ANADROMOUS WATERS CATALOG/ATLAS
CORRECTION FORM

Describe Change(s): Changes involve corrections to annotation where fish species codes are missing or AWC# is in error

Nomination Number: CB-368

From: Barnhill, Carol A (DFG)
Sent: Friday, February 13, 2009 6:19 PM
To: Johnson, J D (DFG)
Subject: AWC species errors

#10
Kr
334-30-11000-2701-3339-4025
CHp,Wp
CHp
CHs
334-30-11000-2701-3339-4007
334-30-11000-2701-3339-4007-5015
CHs,Wp
CHs,Kr,Wp
334-30-11000-2701-3339

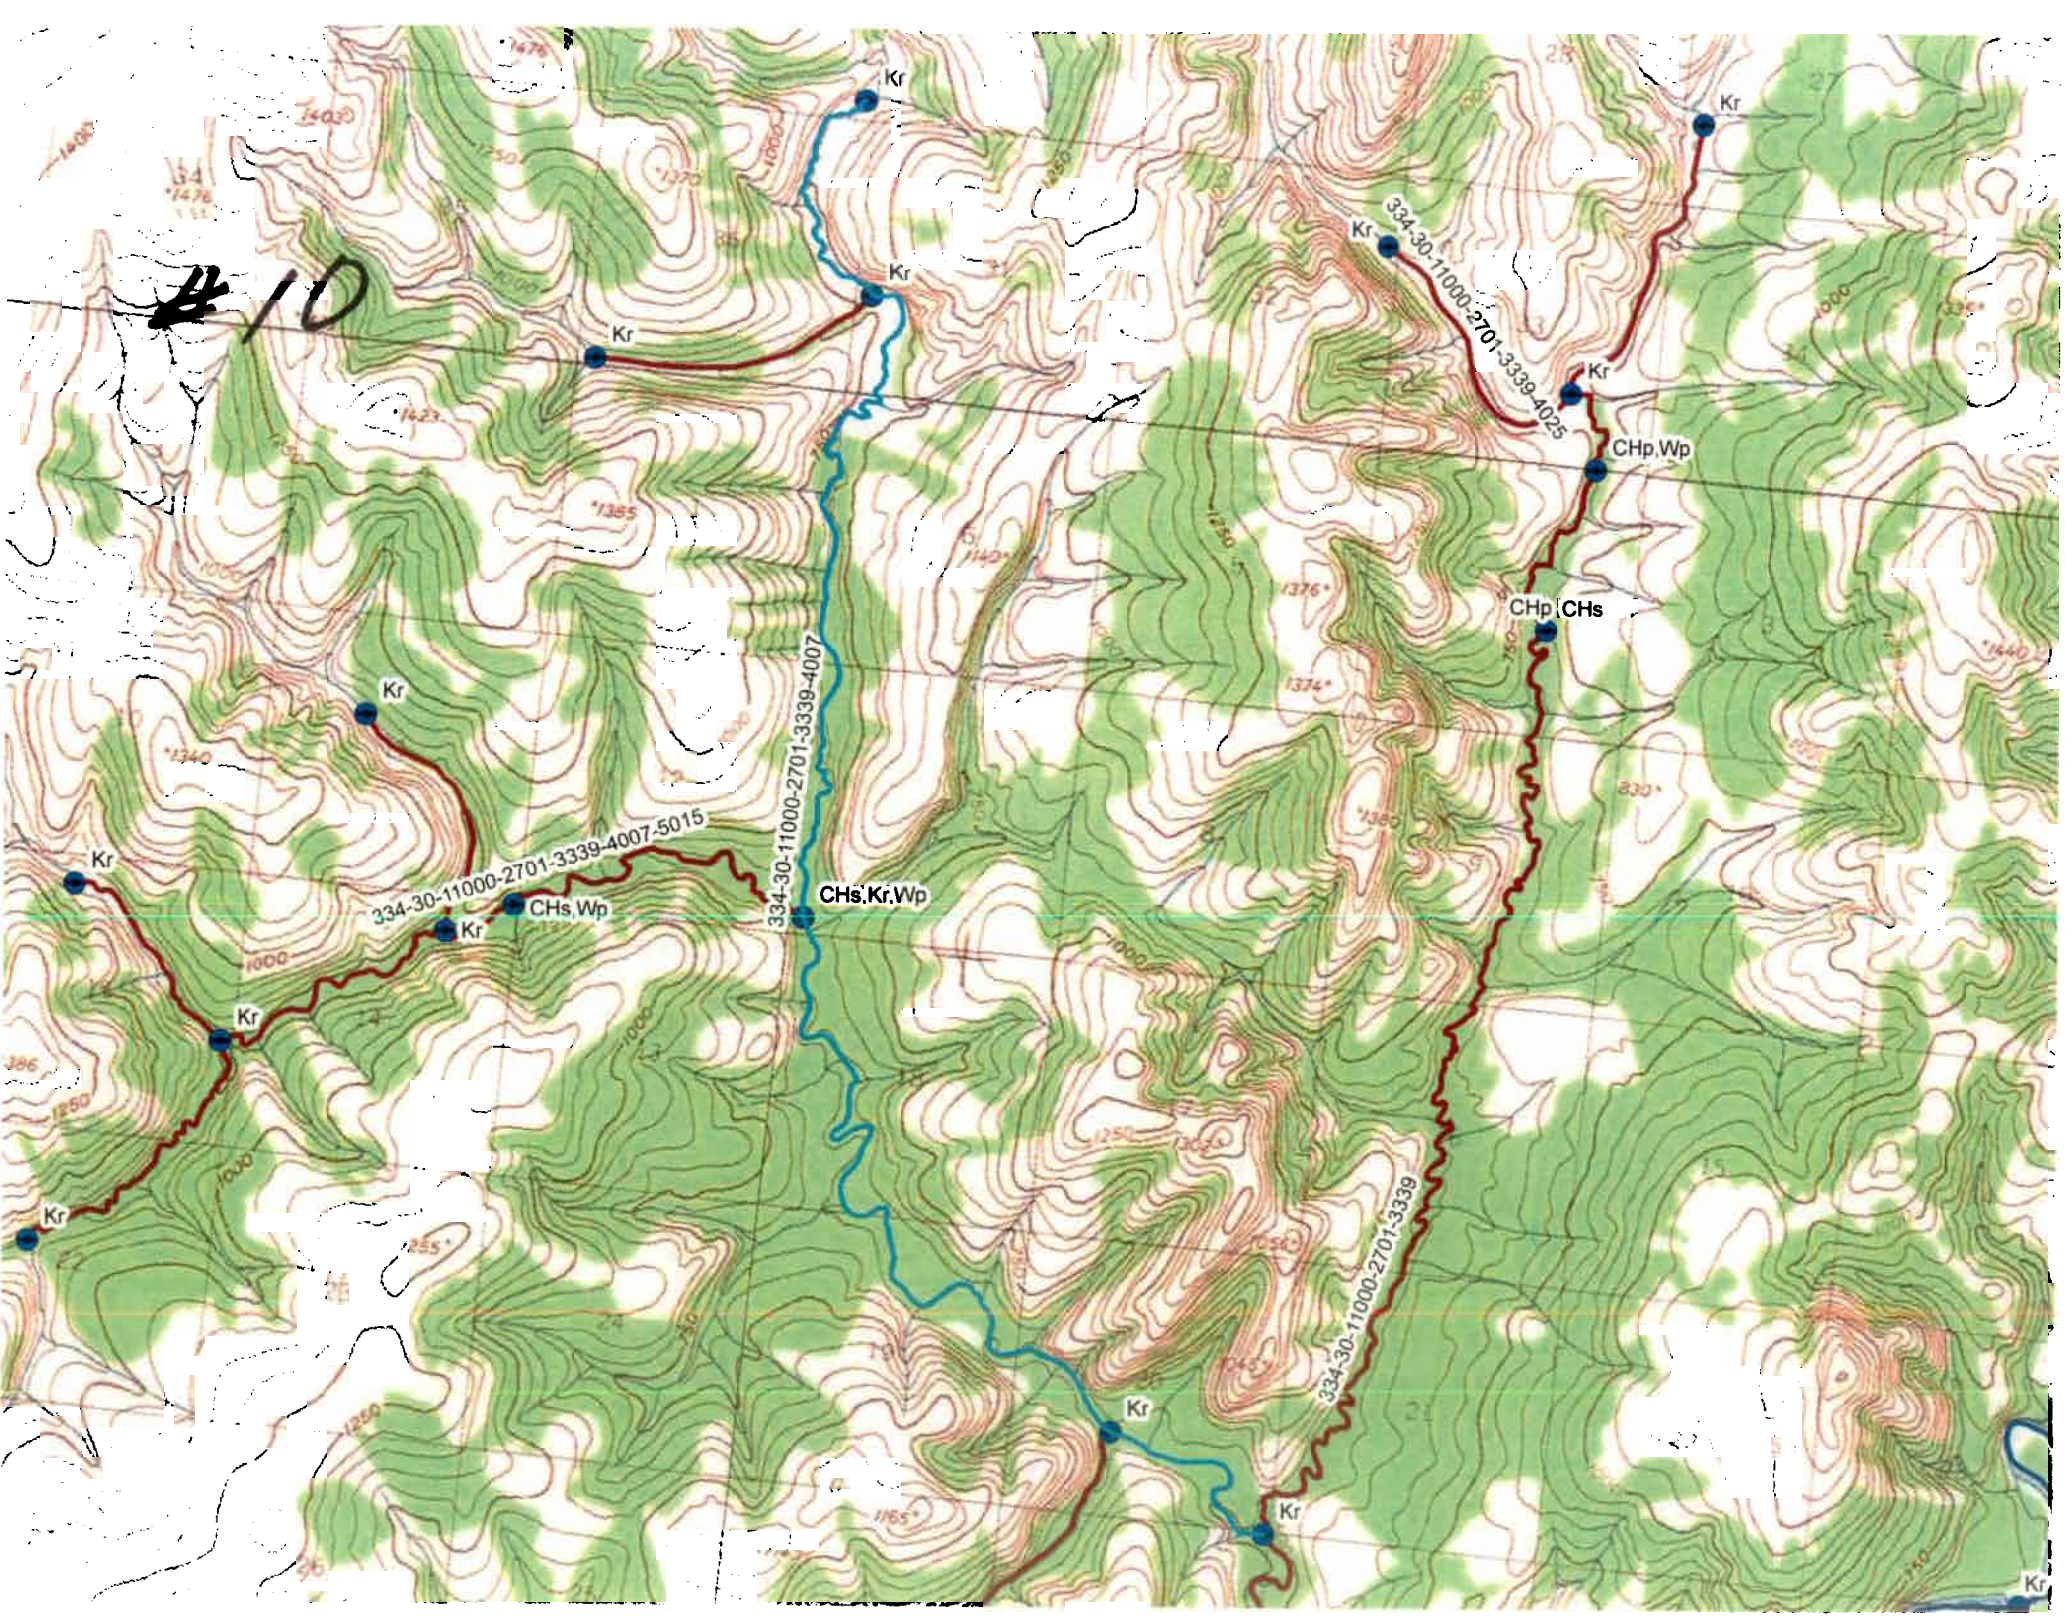
10	334-30-11000-2701-3339-4007-5015	Unalakleet B-4(border quad) A2	No CH,W in -4007
11	334-35-11000-2091-3011-4150-5015	Nulato C-6	No W in -4150

AWC#	Atlas map	Error on map	Corrective action
331-00-10490-2205	Ambler River A-4	No W in -2205	Add Whitefish to water body
333-10-11200-2022	Nome C-1	No DV in -2022	Add Dolly Varden to water body
333-10-11200-2022	Nome C-2	No DV in -2022	Add Dolly Varden to water body
334-30-11000-2701-3339-4007	Unalakleet B-4	No CH,W in -4007	Add Chum salmon & whitefish to water body

5 #12
334-40-11000-2450-3362
COpr
COsr
COpr
COr
COp
COs
334-40-11000-2450-3362-4022
COs
-146.38327, 64.23648

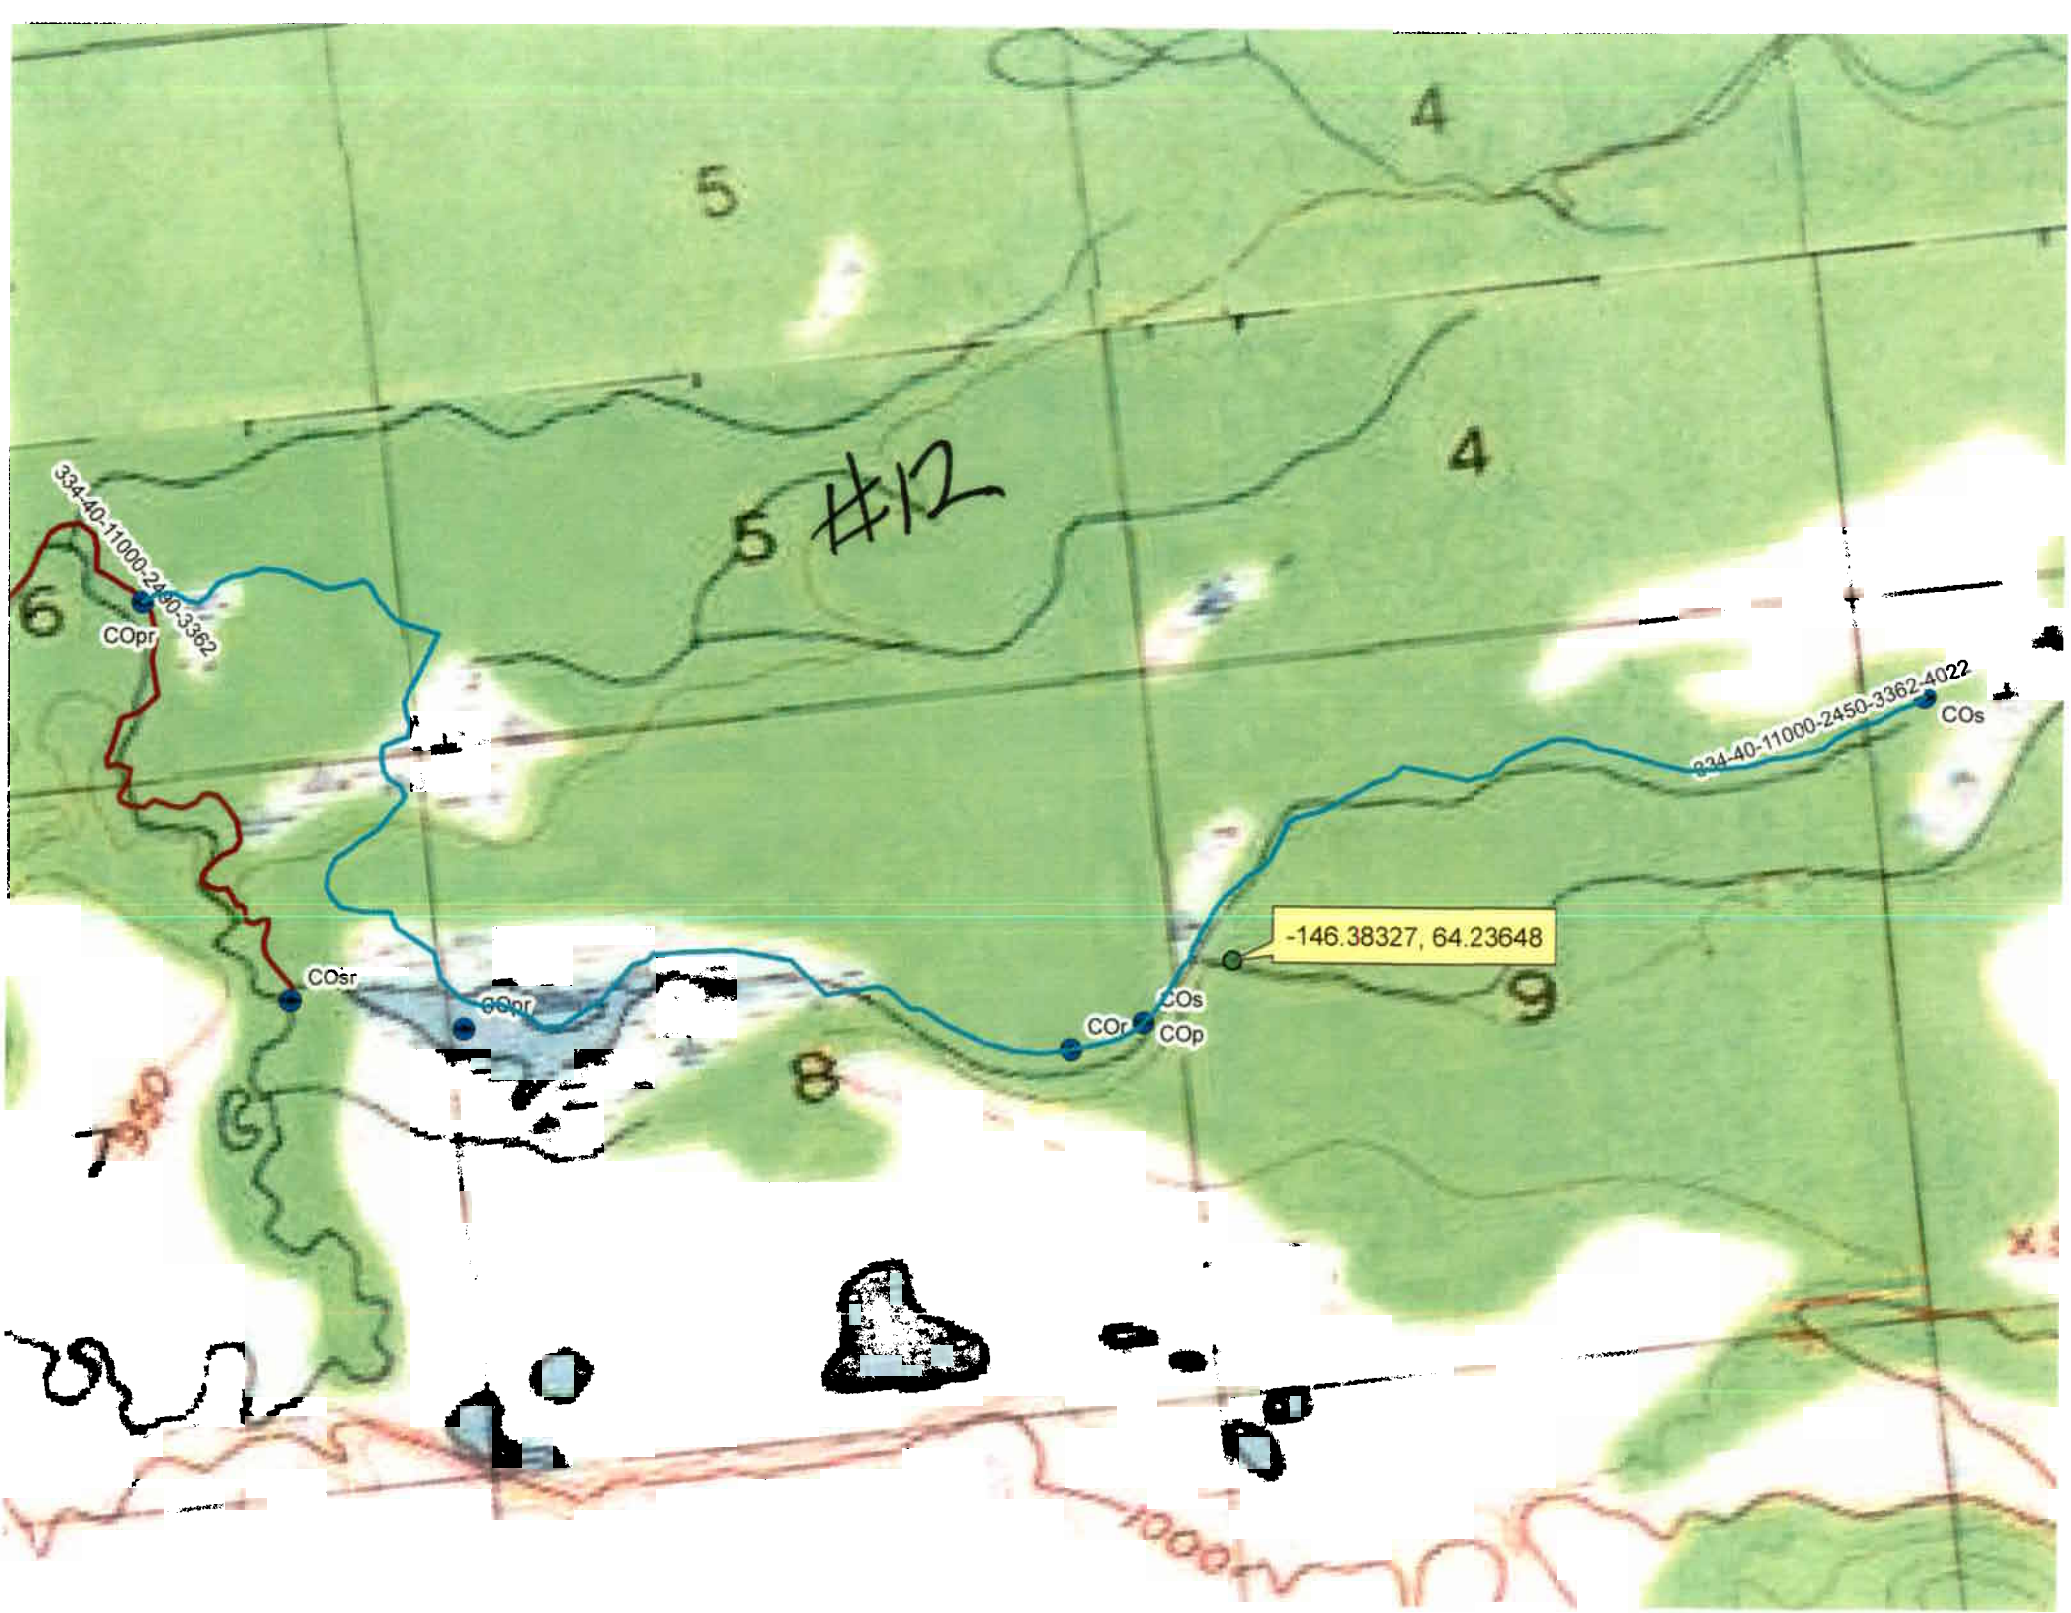
12 Stream and lake 334-40-11000-2450-3362-4022 & -0010 should be -2490-3362-4022 & -0010

AWC#	Atlas map	Error on map	Corrective action
334-40-11000-2450-3362-4022	dB correction/ no map change	AWC # in error	Renumber as 334-40-11000-2490-3362-4022
334-40-11000-2450-3362-4022-0010	dB correction/ no map change	AWC # in error	Renumber as 334-40-11000-2490-3362-4022-0010
334-35-11000-2091-3011-4150	Nulato C-6	No W in -4150	Add Whitefish to water body
334-30-11000-2701-3339-4007	Unalakleet B-4	No CH,W in -4007	Add Chum salmon & Whitefish to water body

AMBLER
331-00-10490-2205
331-00-10490-2205
331-00-10490
CHs,DVp
CHs,DVp
CHp,DVp,W
CHs
INGRICHERK

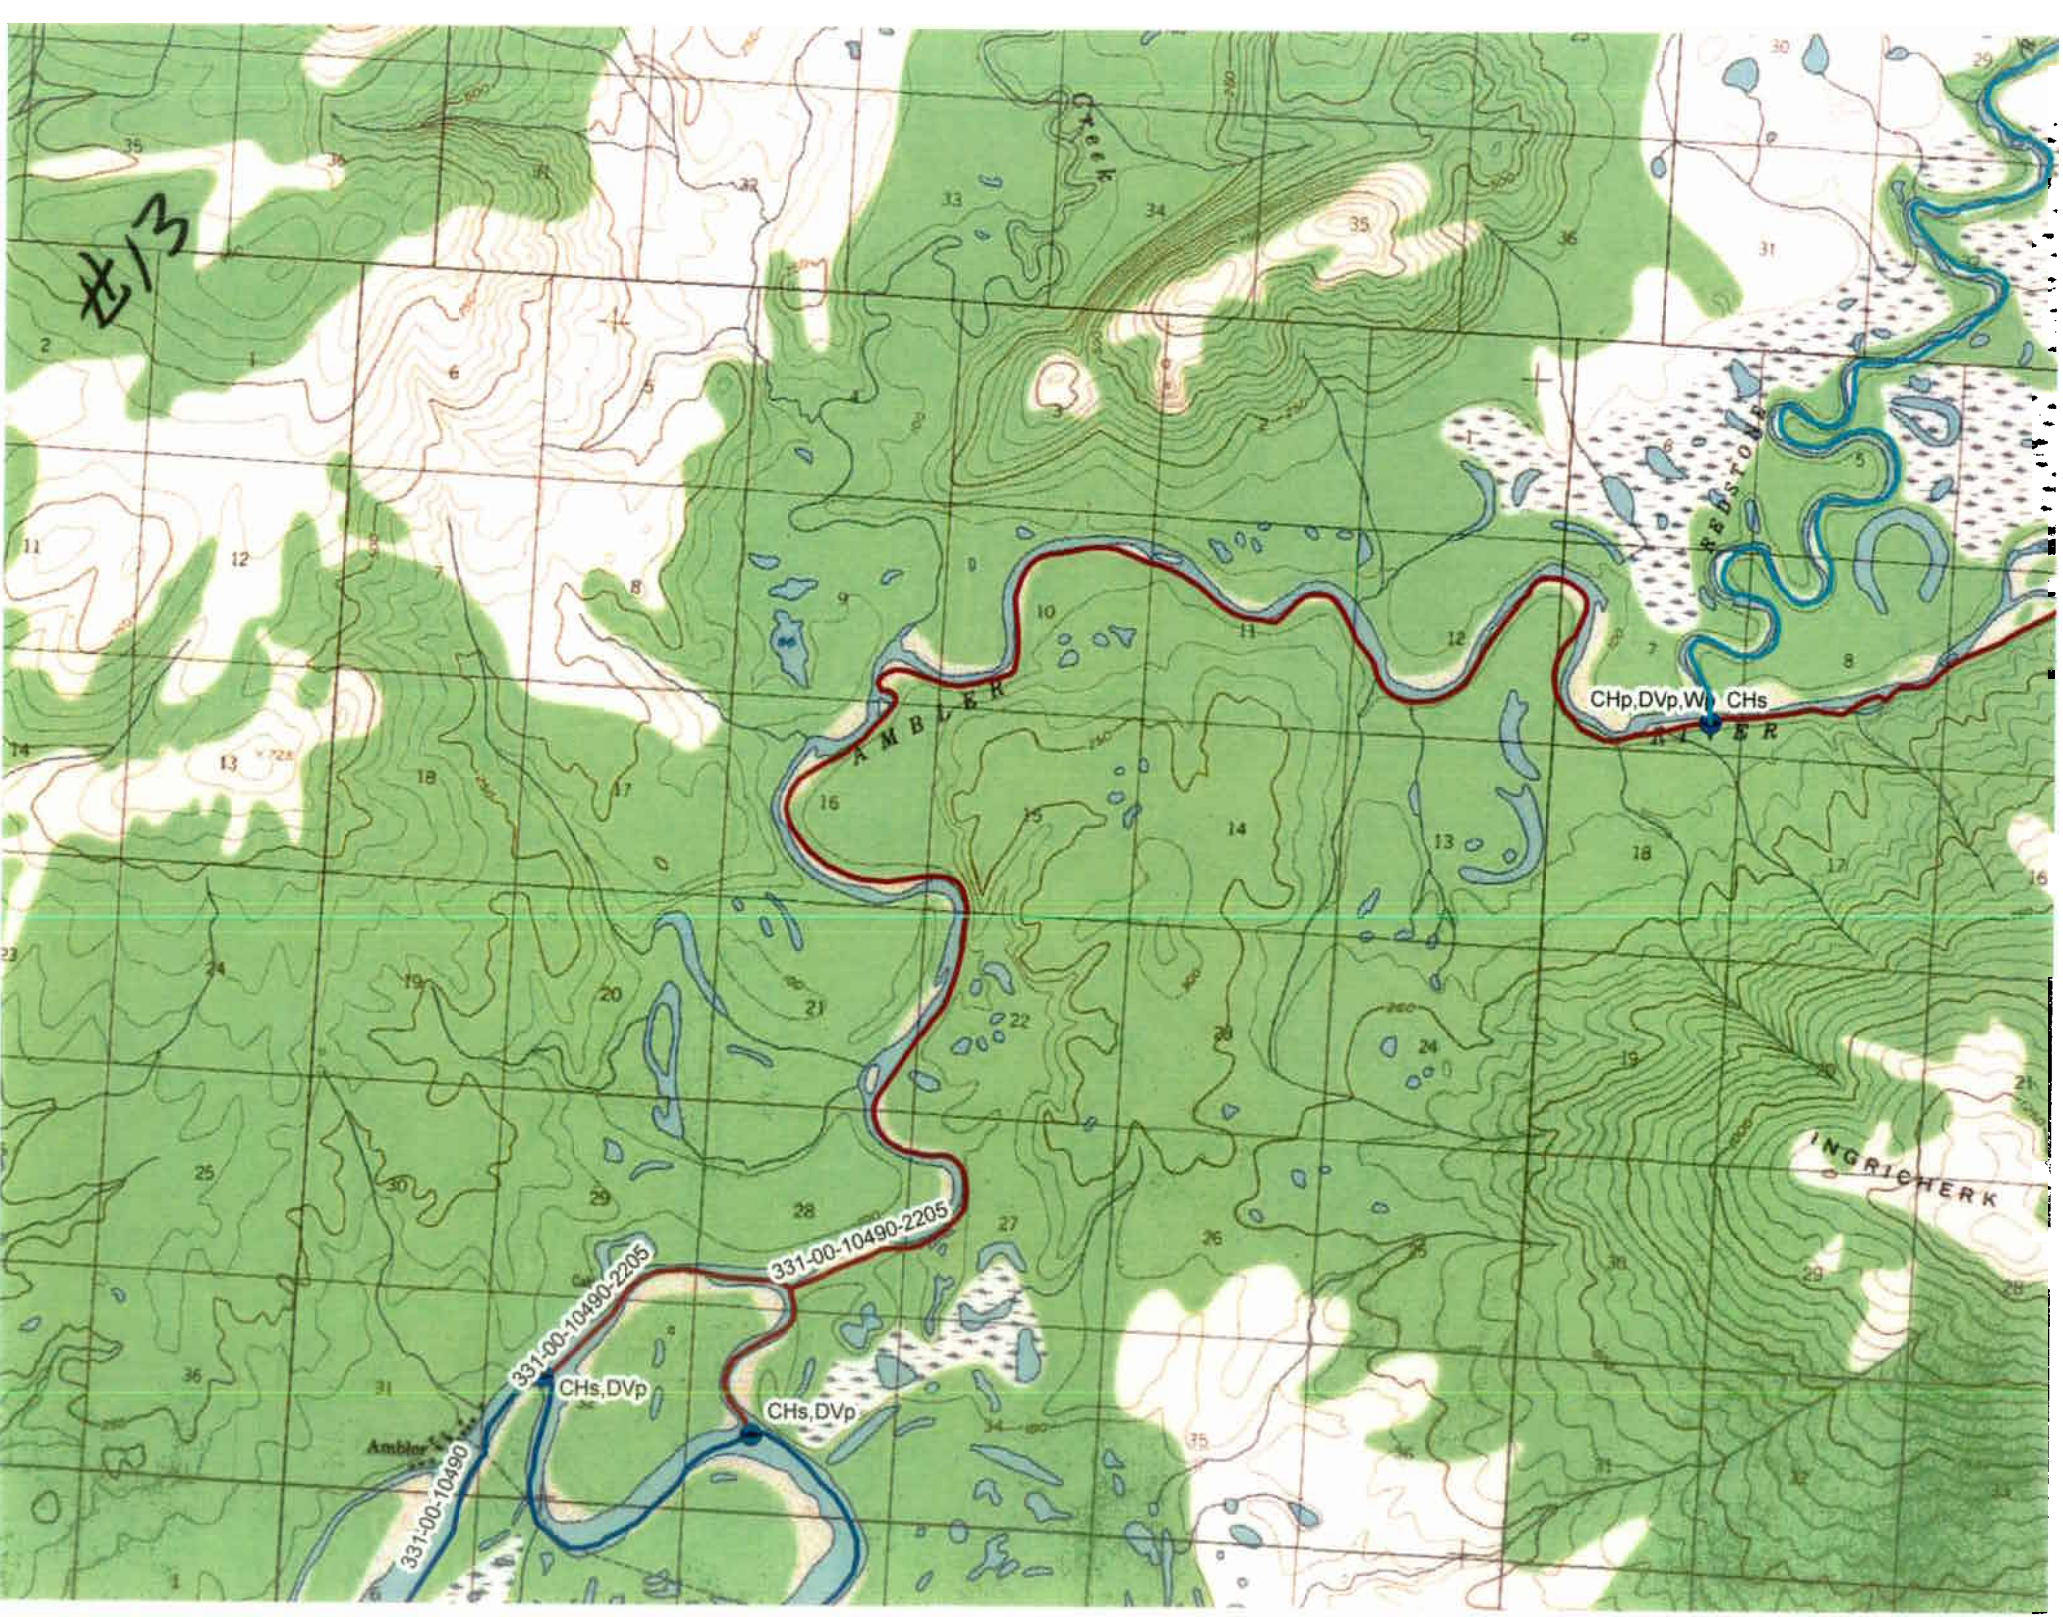
13	331-00-10490-2205-3017	Ambler River A-4	No W in -2205
14	333-10-11200-2022-3019	Nome C-1 & C-2	No DV in -2022
